# MONITORING YEAR 2 ANNUAL REPORT

## VILE CREEK MITIGATION SITE

Alleghany County, NC  
DEQ Contract No. 5999  
DMS Project No. 96582

RE: **Response to MY2 Draft Report Comments**  
**Vile Creek Mitigation Project**  
DMS Project # 96582  
Contract Number 5999  
New River Basin - #CU# 05050001 - Alleghany County, North Carolina

Figure 3.0 Integrated Current Condition Plan View (KEY)  
 Vile Creek Mitigation Site  
 DMS Project No. 96582  
 Monitoring Year 2 - 2018

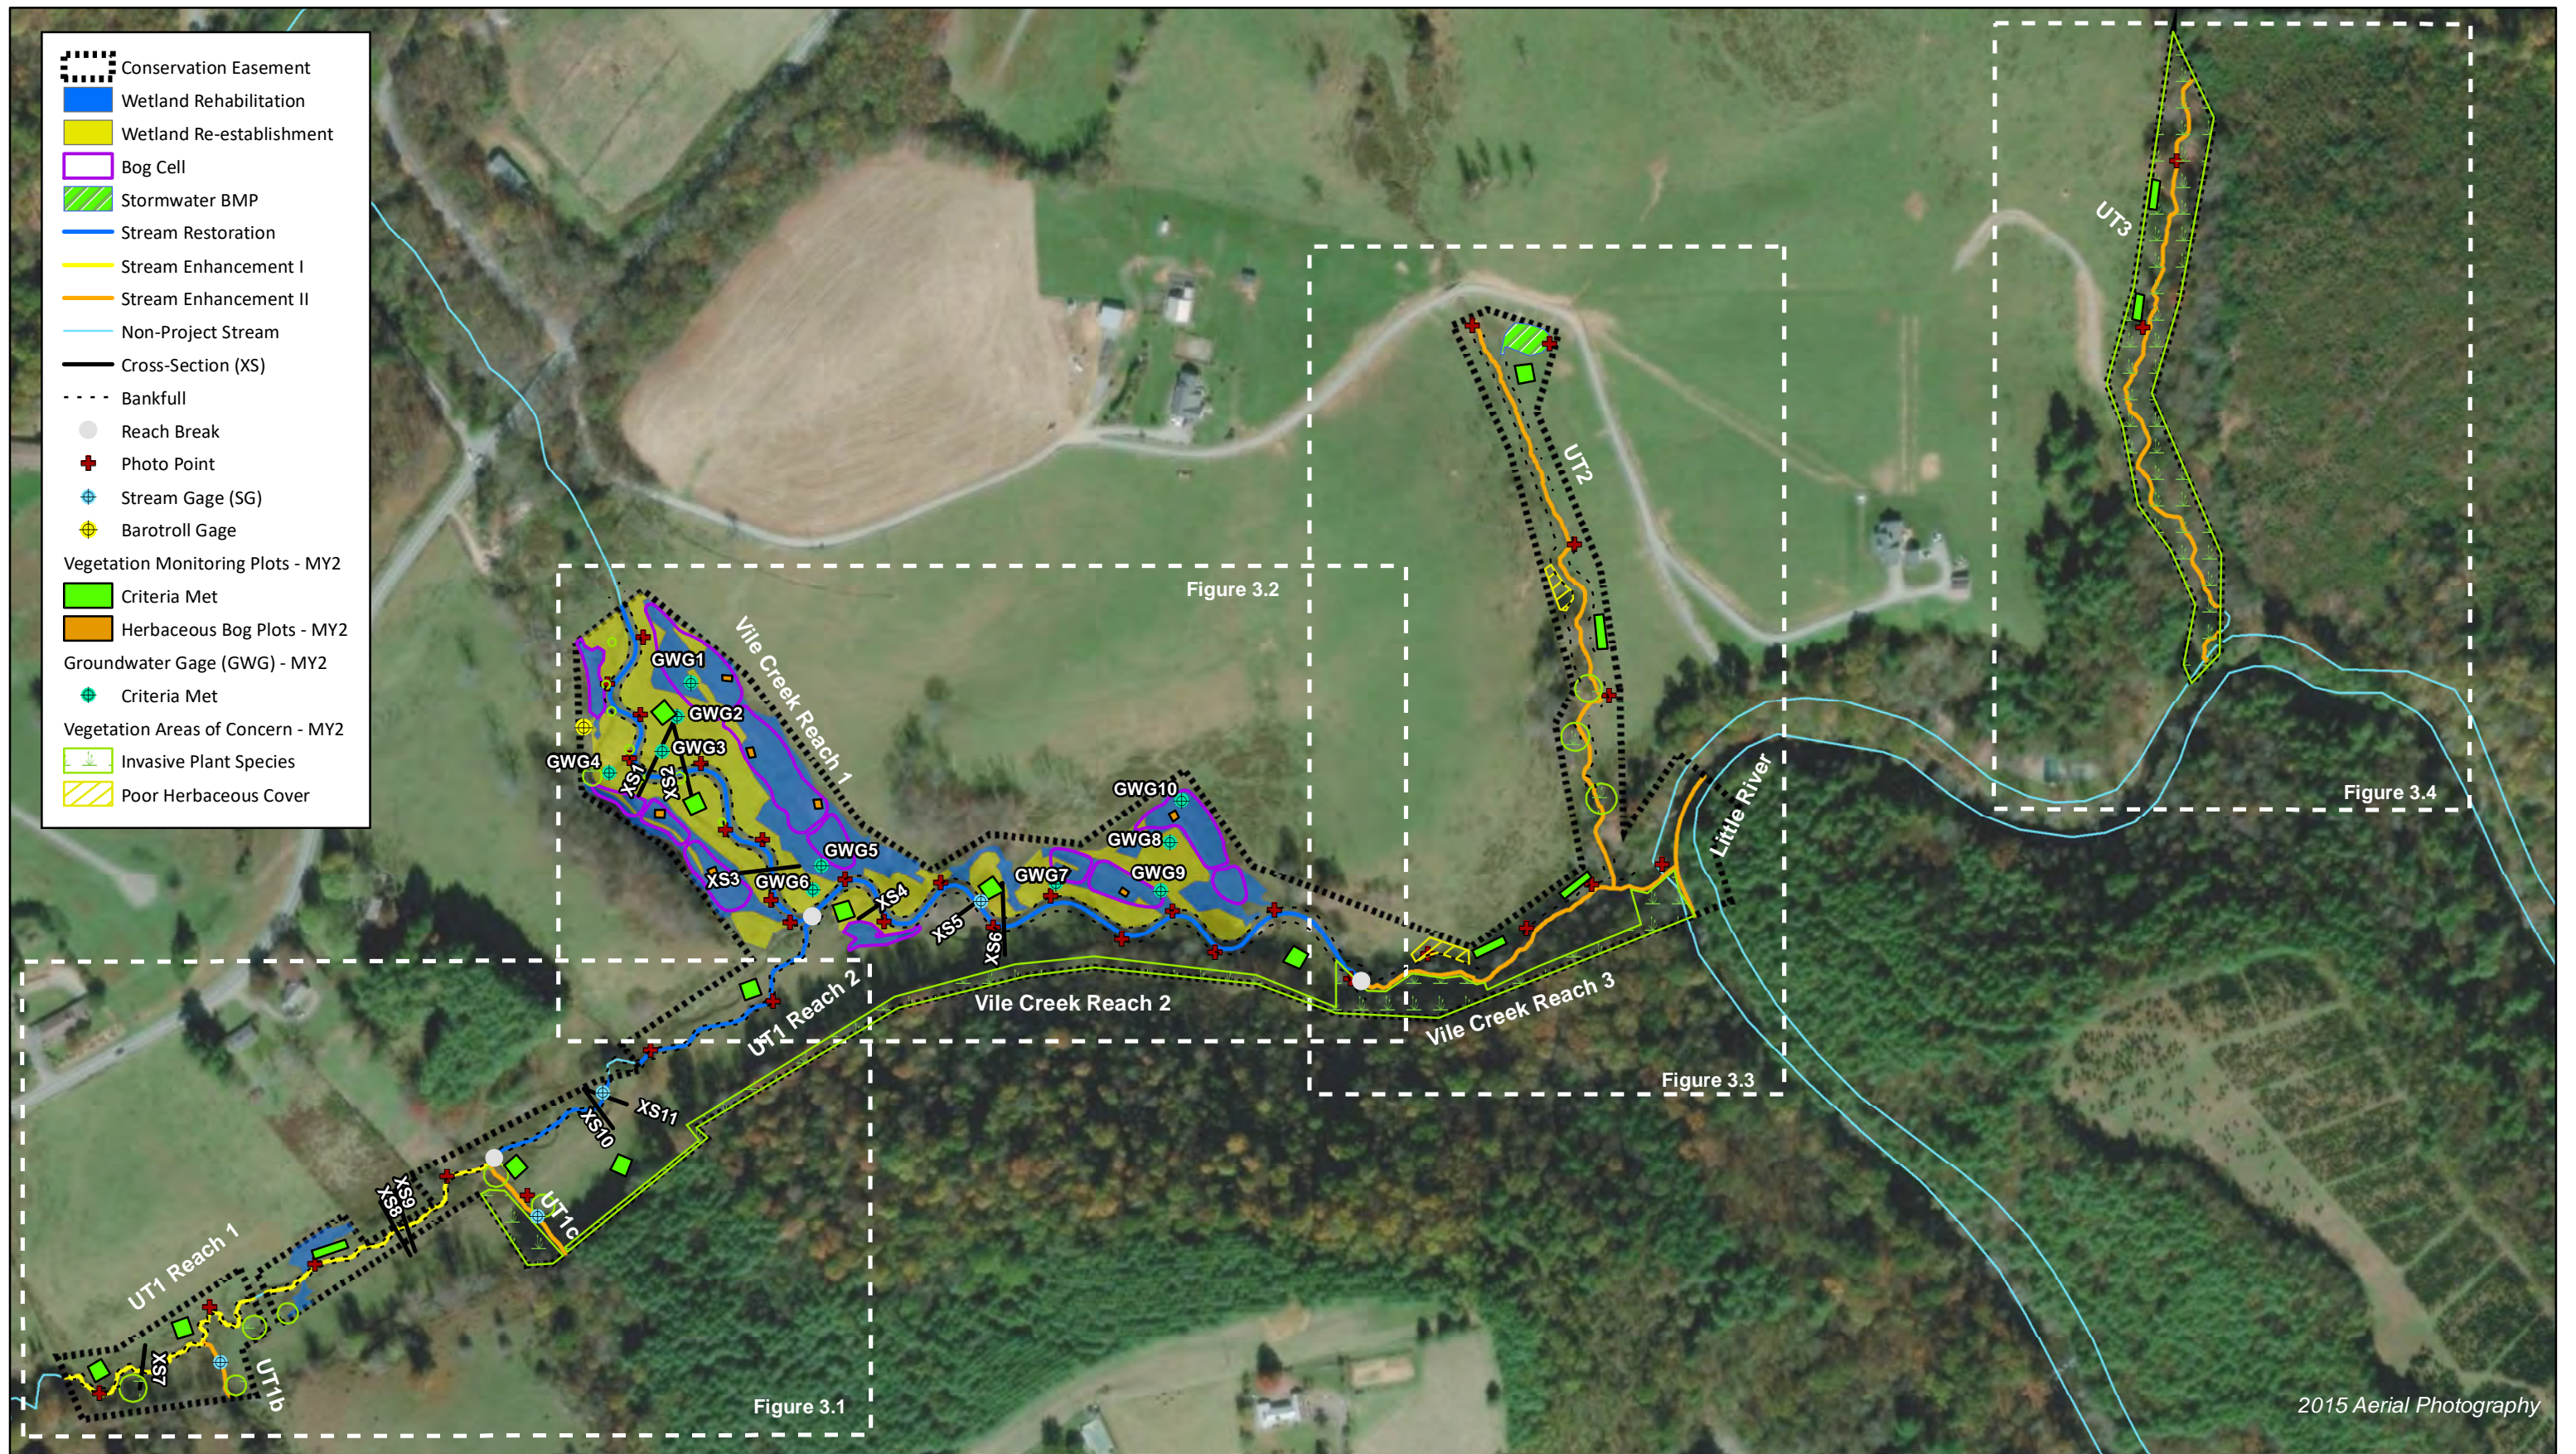
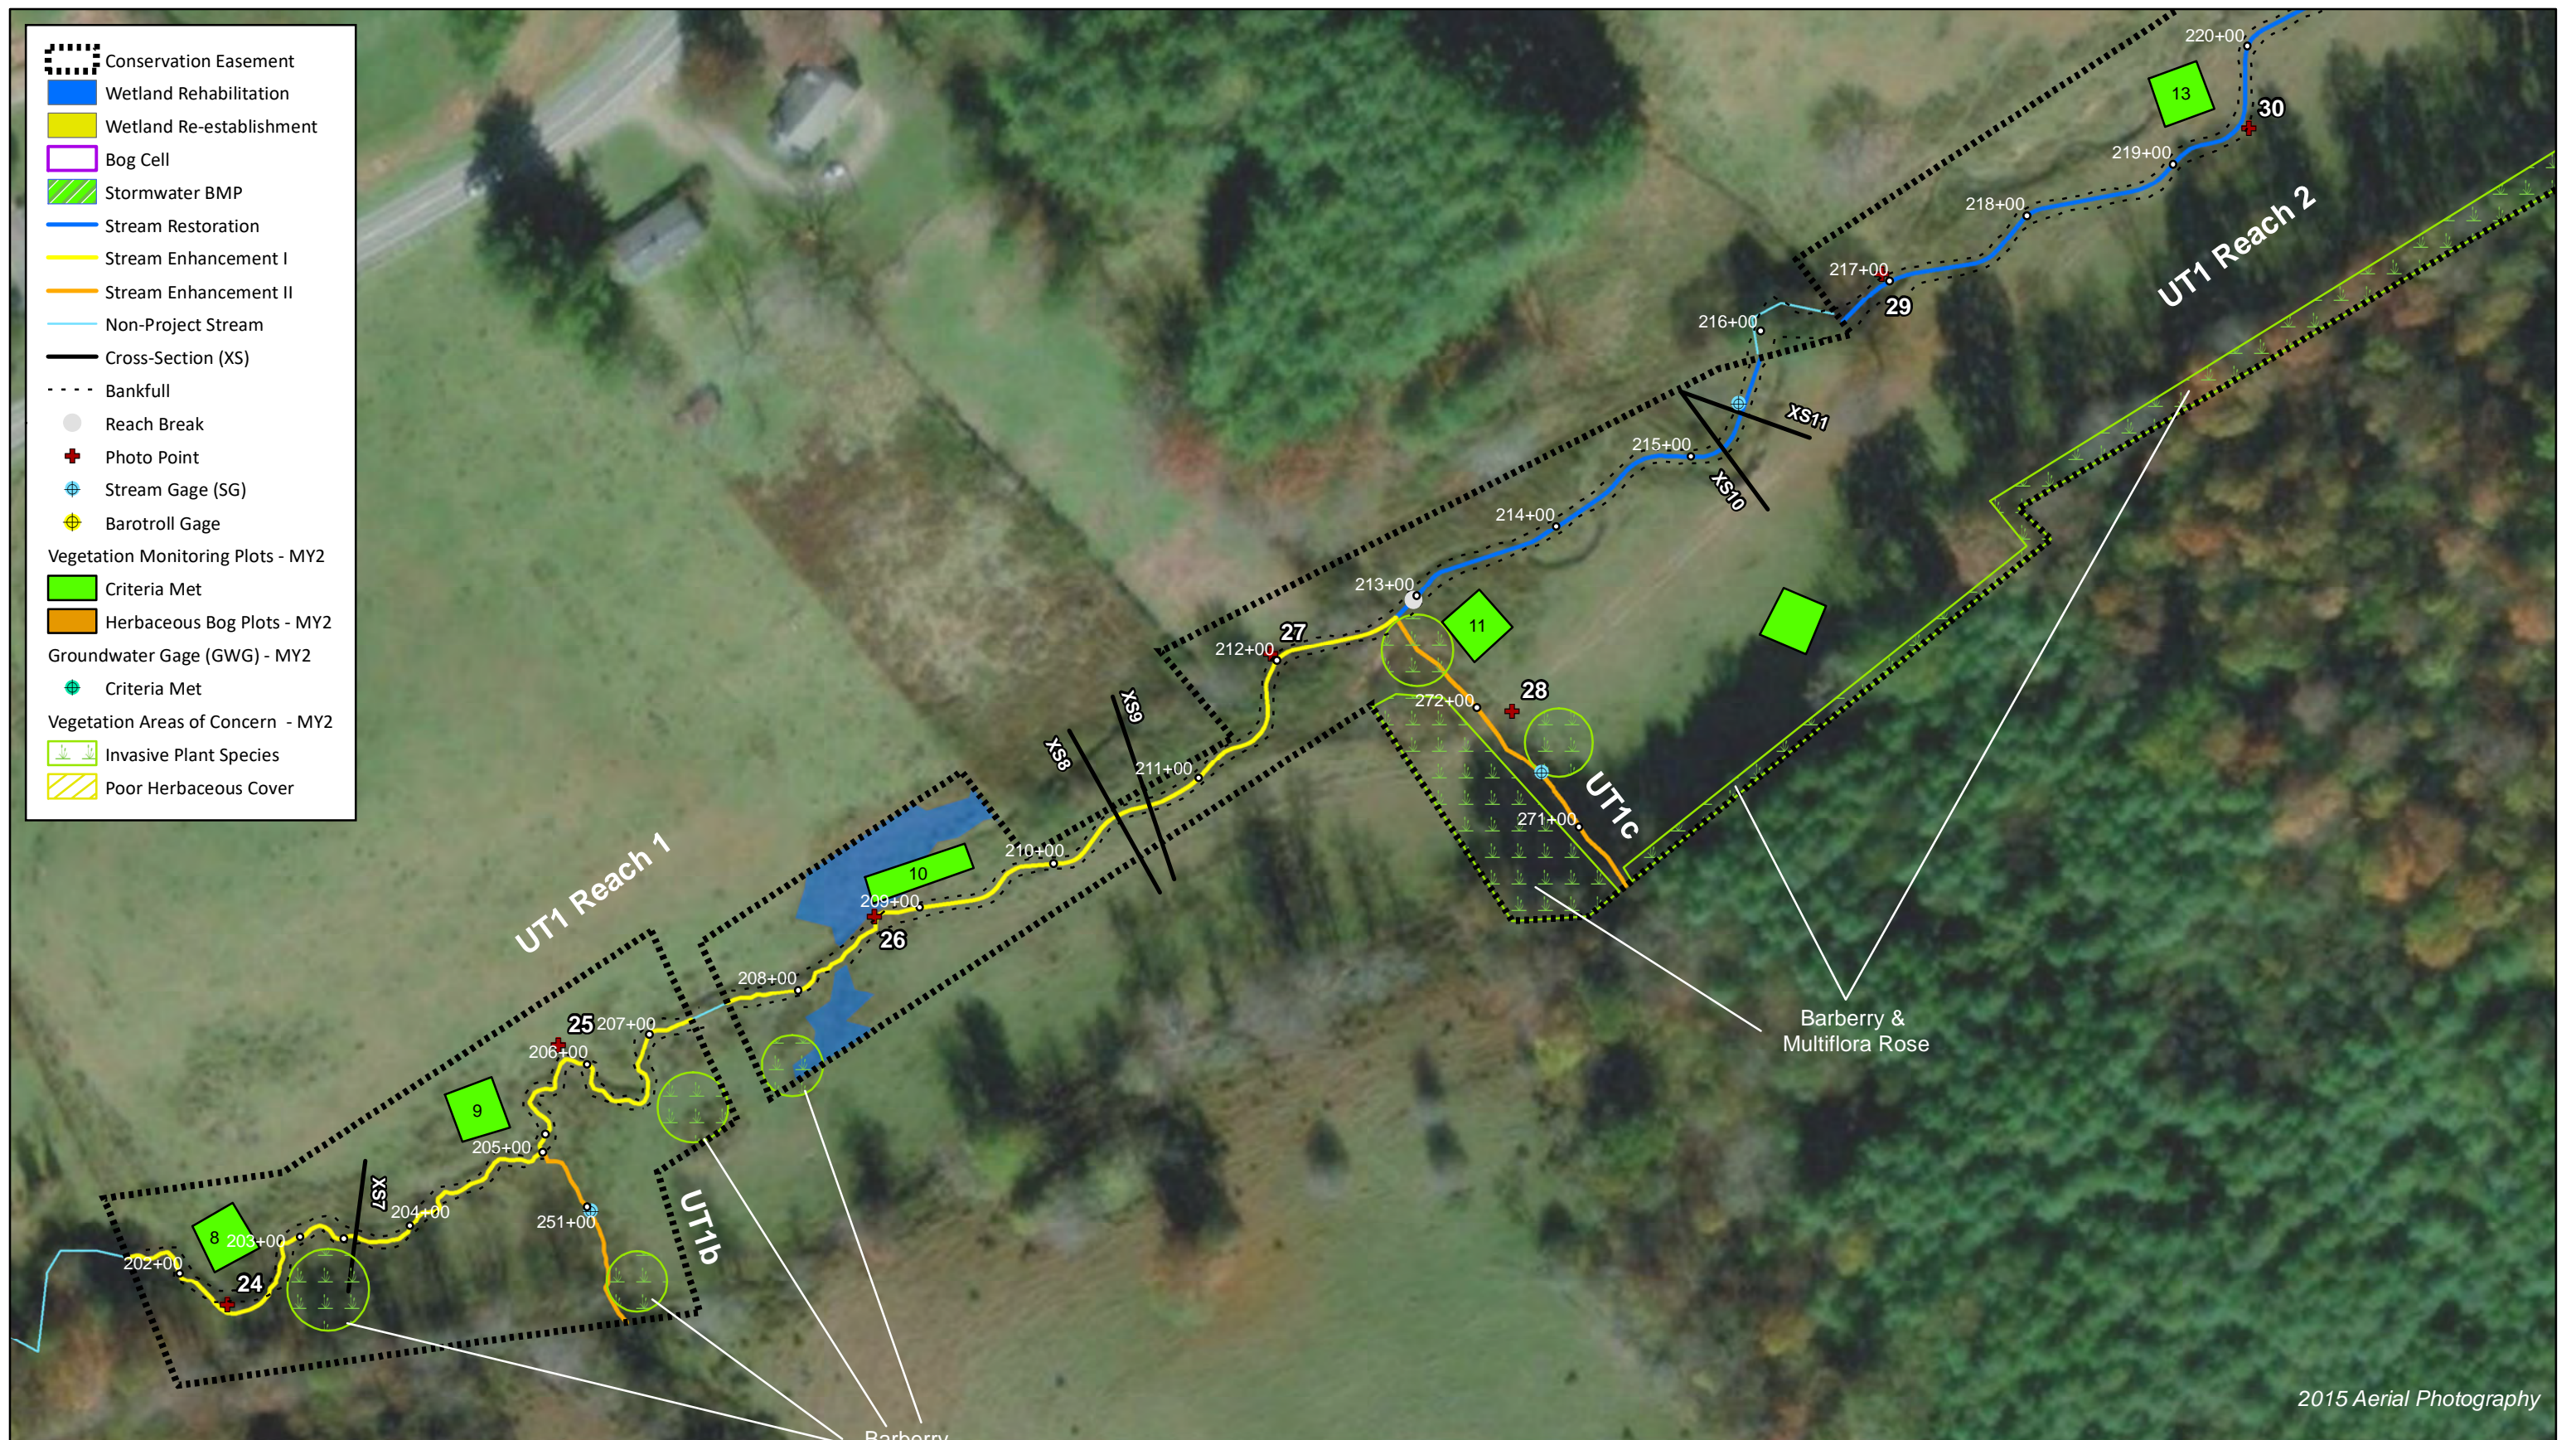
**DMS comment;** It would be helpful to show the station numbers on the CCPVs so the reader can match the narrative with the maps.

**DMS comment;** Visual Assessment tables – Localized areas of scour /erosion are noted in Section 1.2.5; however, the visual assessment tables on some of these reaches indicate 100% performance. In addition, the “Totals” section for ‘Bank’ does not seem to be summed accurately in some instances. Please reexamine the visual assessment tables and provide an up-to-date and accurate depiction of areas of scour/erosion, undercut banks, etc. and totals following the fall 2018 major storm events.

*Wildlands response; Wildlands has updated the CCPV maps to include the longitudinal stationing.*

*Wildlands response; Wildlands has updated the CCPVs to remove the stream areas of concern that do not meet the mapping threshold. The visual assessment tables (5a-5e) were also updated to reflect an accurate depiction of scour/erosion performance. Section 1.2.5 was updated to clarify the areas are under the mapping threshold and correct station numbers.*
